# SERVICE INSTRUCTIONS

No. 1209  
ATA Code 32-30

**SUBJECT:** LANDING GEAR - REPLACEMENT OF THE NOSE LANDING GEAR DOOR HINGE PINS AND REPLACEMENT OF BUSHINGS IN THE NOSE LANDING GEAR DOOR ACTUATING LINKAGE.

Figure 1

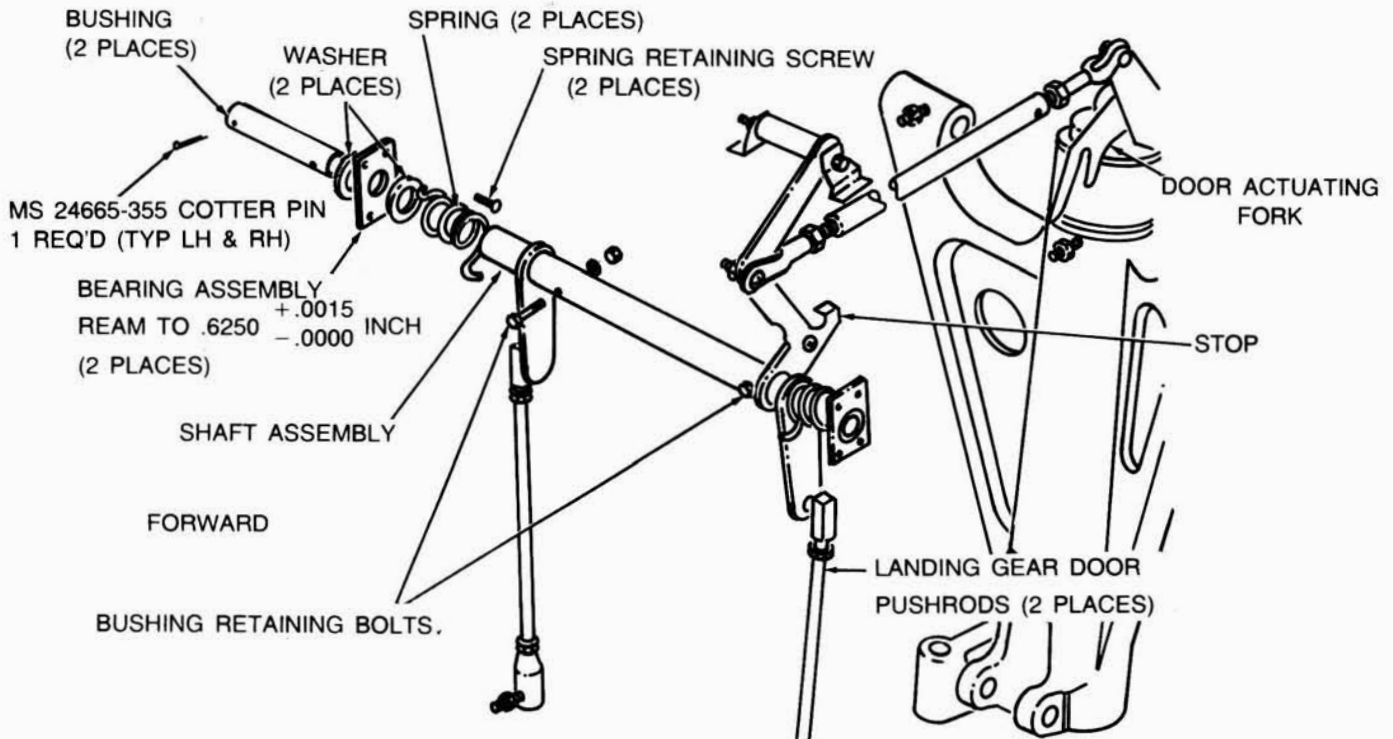
- e. Remove the bushings (refer to Figure 1) by removing the bushing retaining bolts, the spring retaining screws and pulling the bushings outboard. The LH bushing will be removed through the forward nose compartment floor.

After the LH bushing is removed, it may be necessary to remove the RH bushing by inserting several short socket extensions, one at a time, through the opening in the LH keel, and pushing the RH bushing out.

4. Ream the P/N 105-410000-21 bearing assemblies to .6250/.6265 inch. Replace the landing gear bushings, following the directions specified in Kit No. 76-8003-1 S. Kit No. 76-8003-1 S is included as part of Kit No. 76-8004-1 S and Kit No. 76-8004-3 S.

Figure 2

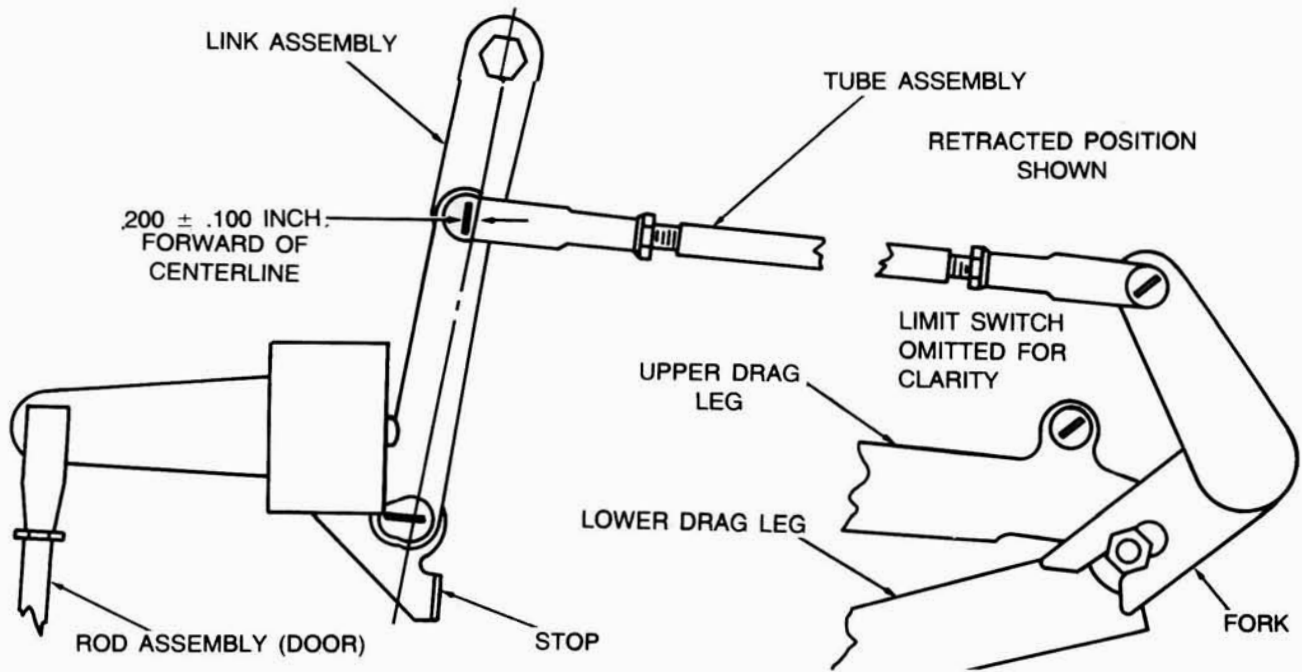
6. With doors disconnected, manually retract the nose landing gear and adjust the fore-and-aft pushrod in the nose landing gear door actuating mechanism (see Figure 2), so the pin on the left side of the drag brace knee engages the door actuating fork SLOT as the landing gear retracts. Hydraulically retract the landing gear and fine adjust so that the forward pivot arms move to within  $.200 \pm$

.100 inch forward of the on-center position. This should allow the pin on the left side of the drag brace knee to properly engage the door actuating fork SLOT. Cycle the landing gear and observe for proper operation.

Excessive lengthening of the rod causes the pin to engage the fork from below, pulling the forward pivot to an over-center position. If this condition exists, the nose gear doors will prohibit either manual or emergency extension of the nose landing gear. Excessive shortening of the rod results in an over-center position of the nose pivot. If this condition exists, emergency extension of the nose landing gear may be impaired.
